Product Change Notification

PCN26-46 - K12 Series – Packaging update for K12GS

Design evolution:

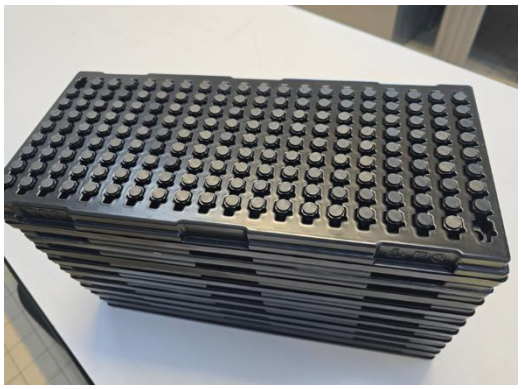
Packaging updated from bulk to tray.

Old in Bulk

New in Tray

Old packaging in Bulk:
250 pcs in plastic bag / small carton_ 150x95x95 mm
32 small cartons / Carton so **8000 pcs** / Carton 385x385x330 mm
Weight: 11 kg / carton

New Packaging in Tray:
178 pcs / trays _ 410*250*30 mm
10 trays / Carton so **1780 pcs** / Carton 410*250*200
Weight: 3.5 kg / carton
